P1 Project Drawing Updates - 10/22/2019

BR-549-A-002

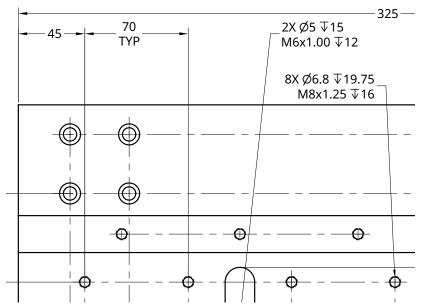
Groove diameter was missing
